17-113V – YODER RESIDENCE

A Non-Use (Area) Variance to increase the allowable accessory structure height from 12 feet to 21 feet for construction of a two-story detached accessory building.

Staff Recommendation

Disapproval of a Non-Use (Area) Variance

3. Site Plan

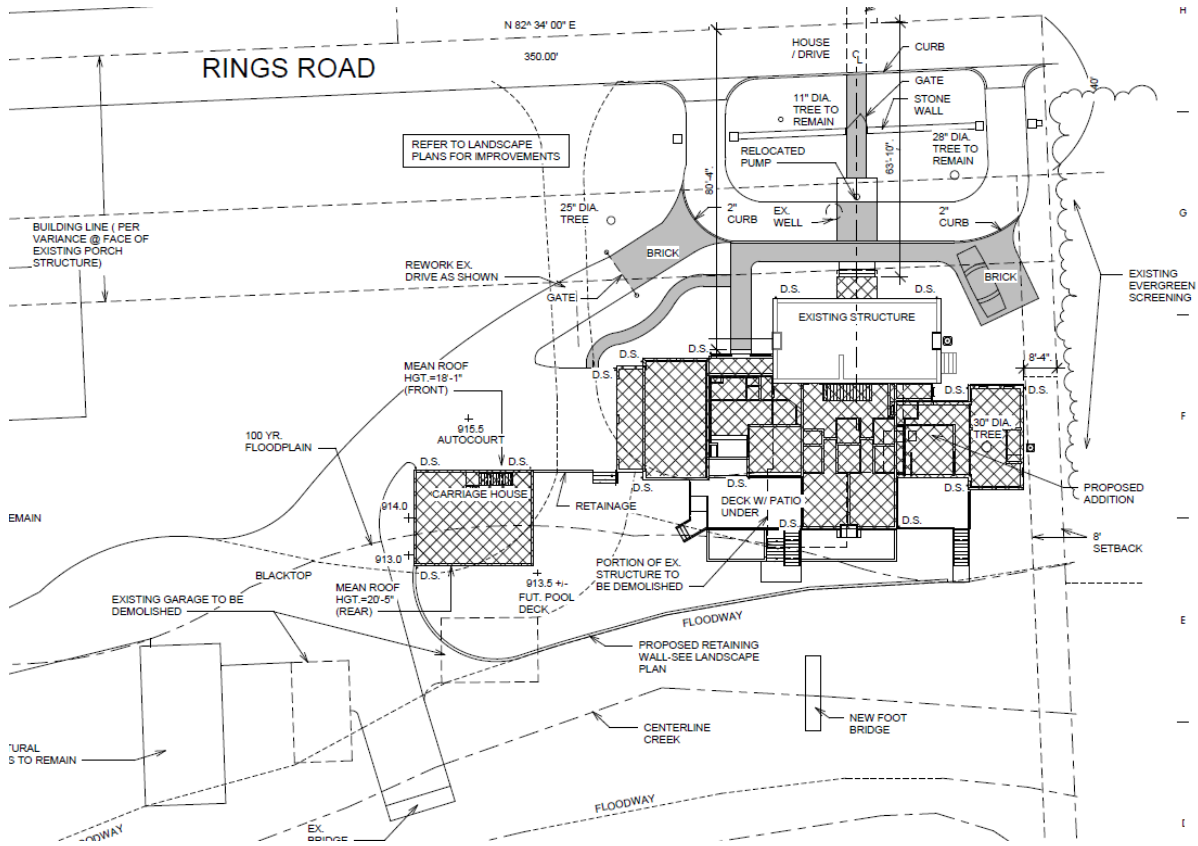
The site contains an existing single-family buildings and multiple accessory structures. The detached accessory building is proposed to the west of the residence.

Criteria Not Met. The applicant would be able to adhere to the height requirement without extenuating circumstances of the site. The applicant has the option to construct a one-story structure to meet the zoning requirements. There is an approximate 1.5 foot grade change at this portion of the site which impacts the overall height. However, the applicant could move the building further to the west and meet the overall height

requirement. A single story structure would meet the 12-foot height requirement. Therefore, the current site conditions would not warrant a special condition designation for this property.

Criteria Not Met. The applicant is requesting to increase the height of the detached accessory building to allow for a two-story garage. Detached accessory structures within this zoning district currently meet the height requirement. The applicant would have options, including other areas on the site with less of a grade change, to meet the required 12 foot height limit.

The proposed Non-Use (Area) Variance is not consistent with all applicable review criteria. **Disapproval** is recommended for the request to permit a 21 foot high detached accessory building.
